**SERVICE BULLETIN 04
(Reprint)**

FROM: Pete Gustafson, Field Service Mgr.
TO: Service Managers
DATE: April 12, 1988
RE: Secret Service - Ball Trap

FIGURE 1

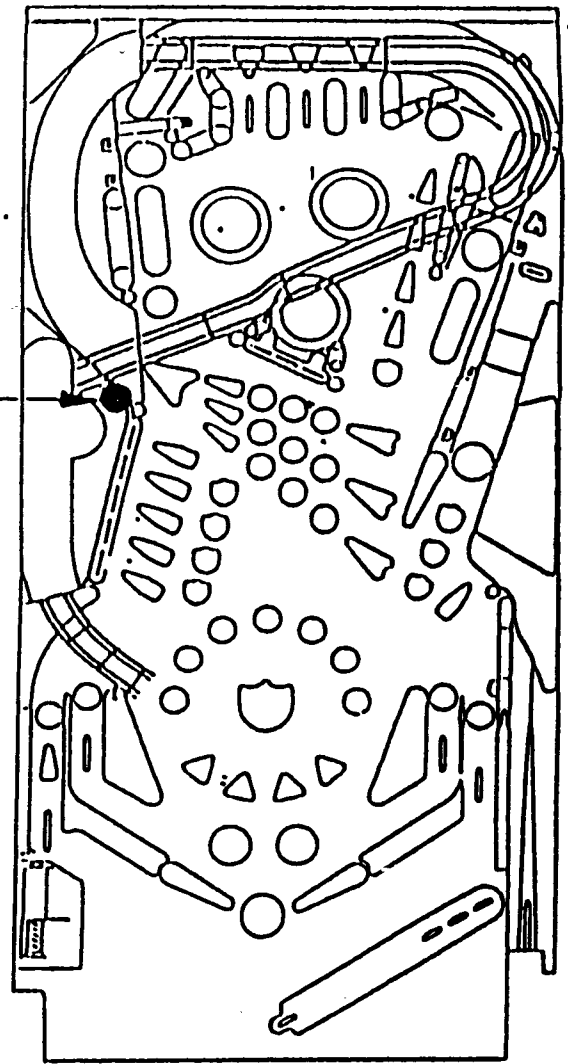
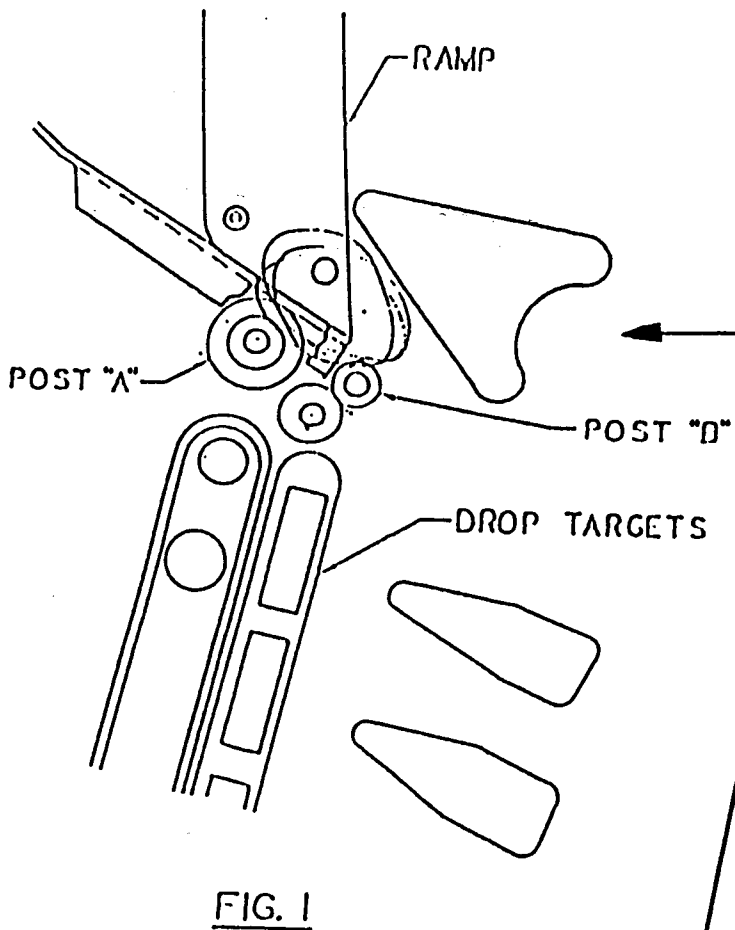
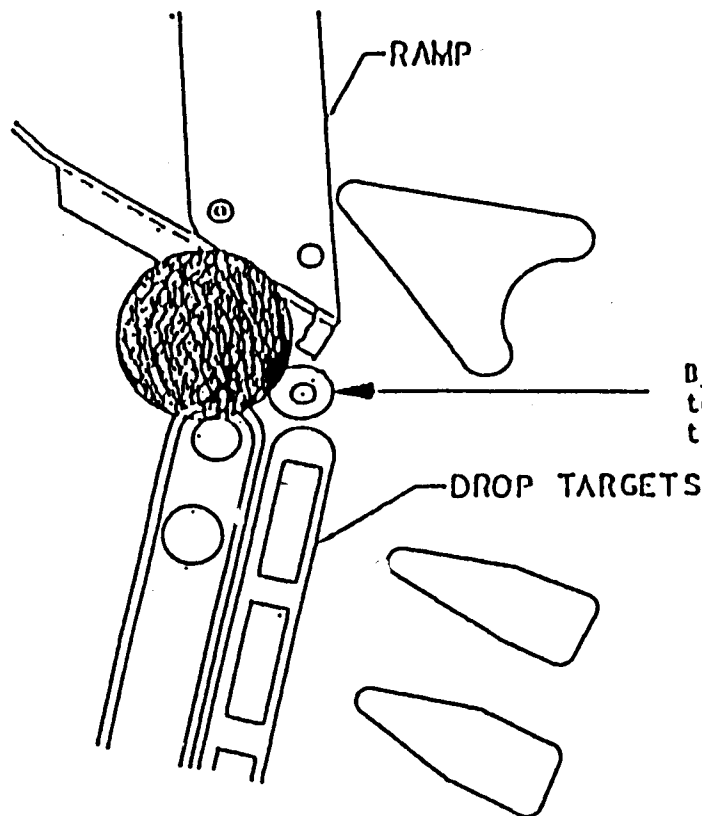
Symptom: Ball gets trapped on top of the post that is in front of the ramp, the screened plastic cover over the drop targets, and the side of the wire ramp going into the white house (see Fig. 1 & Fig. 2).

Problem: The post in front of the ramp is too tall.

Two posts must be added to fully protect the left entrance wall of the ramp. The red plastic post should be placed behind the left wall, shown as post "A" in Fig. 1. This post prevents the wall from being flexed by ball pressure. The machine screw mini post must be placed in front of the left wall at the entrance shown as post "B" in Fig. 1. A 11/64" hole must be drilled for post "B."

By snipping off the top of this post, the ball will not be able to rest in the position shown.

1. Remove the acorn nut from the top of the post.
2. Using a heavy pair of side cutters, snip off the threaded portion of the post.
3. File any burrs off the post.
